Joseph M. Farley Nuclear Plant  
License Amendment Request for Adoption of TSTF-425-A, Revision 3,  
Risk-Informed Justification for the Relocation of Specific Surveillance Frequency  
Requirements to a Licensee Controlled Program  
Using the Consolidated Line Item Improvement Process

- Enclosures:
1. Basis of Proposed Change
  2. Documentation of PRA Technical Accuracy
  3. Markup for FNP Proposed TS Changes
  4. Clean Typed Pages for FNP Proposed TS Changes
  5. Markup for FNP Proposed TS Bases Changes
  6. Technical Specification Cross Reference for FNP and TSTF 425 Mark ups

**Joseph M. Farley Nuclear Plant  
License Amendment Request for Adoption of TSTF-425-A, Revision 3,  
Risk-Informed Justification for the Relocation of Specific Surveillance  
Frequency Requirements to a Licensee Controlled Program  
Using the Consolidated Line Item Improvement Process**

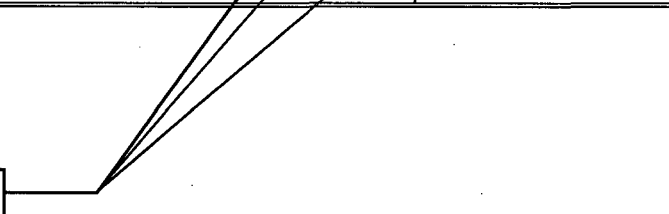
SURVEILLANCE		FREQUENCY
SR 3.4.9.1	Verify pressurizer water level is $\leq$ 63.5% indicated.	12 hours
SR 3.4.9.2	Verify capacity of each required group of pressurizer heaters is $\geq$ 125 kW.	92 days
SR 3.4.9.3	Verify required pressurizer heaters are capable of being powered from an emergency power supply.	18 months

Insert 1

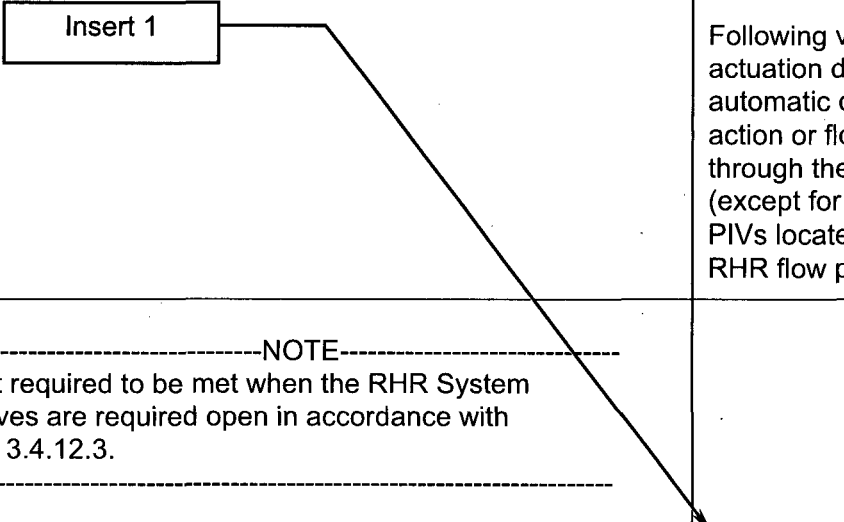
SURVEILLANCE	FREQUENCY
<p>SR 3.4.13.1</p> <p>-----NOTES-----</p> <p>1. Not required to be performed in MODE 3 or 4 until 12 hours of steady state operation.</p> <p>2. Not applicable to primary to secondary LEAKAGE.</p> <p>-----</p> <p>Verify RCS operational LEAKAGE is within limits by performance of RCS water inventory balance.</p>	<p>-----NOTE-----</p> <p>Only required to be performed during steady state operation</p> <p>-----</p> <p>72 hours</p>
<p>SR 3.4.13.2</p> <p>-----NOTE-----</p> <p>Not required to be performed until 12 hours after establishment of steady state operation.</p> <p>-----</p> <p>Verify primary to secondary LEAKAGE is <math>\leq 150</math> gallons per day through any one SG.</p>	<p>72 hours</p>

Insert 1

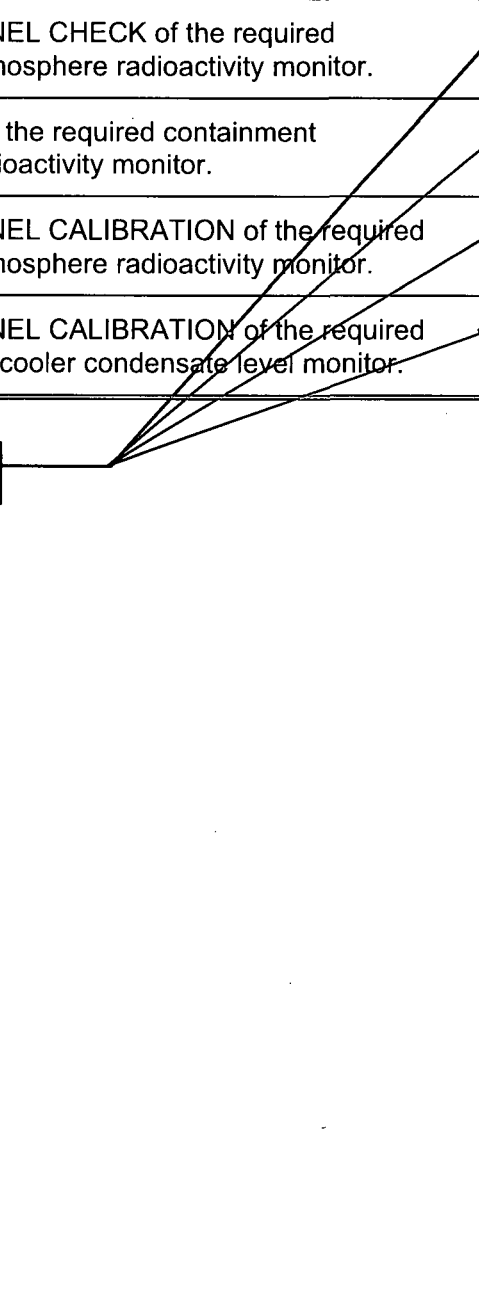
SURVEILLANCE		FREQUENCY
SR 3.4.15.1	Perform CHANNEL CHECK of the required containment atmosphere radioactivity monitor.	12 hours
SR 3.4.15.2	Perform COT of the required containment atmosphere radioactivity monitor.	92 days
SR 3.4.15.3	Perform CHANNEL CALIBRATION of the required containment atmosphere radioactivity monitor.	18 months
SR 3.4.15.4	Perform CHANNEL CALIBRATION of the required containment air cooler condensate level monitor.	18 months

Insert 1

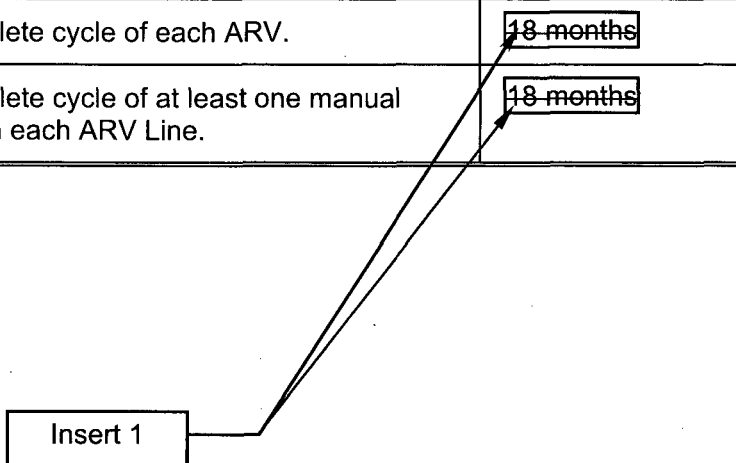
SURVEILLANCE		FREQUENCY
SR 3.7.4.1	Verify one complete cycle of each ARV.	18 months
SR 3.7.4.2	Verify one complete cycle of at least one manual isolation valve in each ARV Line.	18 months

Insert 1

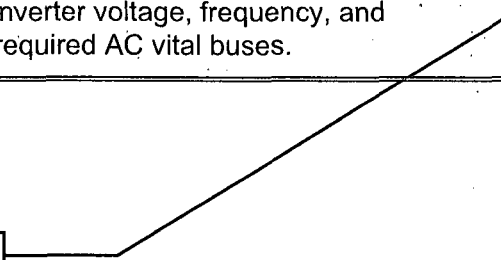
SURVEILLANCE	FREQUENCY
SR 3.8.8.1 Verify correct inverter voltage, frequency, and alignments to required AC vital buses.	7 days

Insert 1

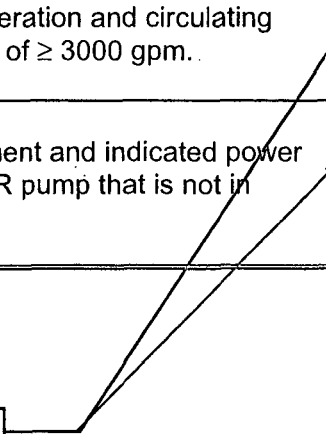
SURVEILLANCE		FREQUENCY
SR 3.9.5.1	Verify one RHR loop is in operation and circulating reactor coolant at a flow rate of $\geq 3000$ gpm.	12 hours
SR 3.9.5.2	Verify correct breaker alignment and indicated power available to the required RHR pump that is not in operation.	7 days

Insert 1
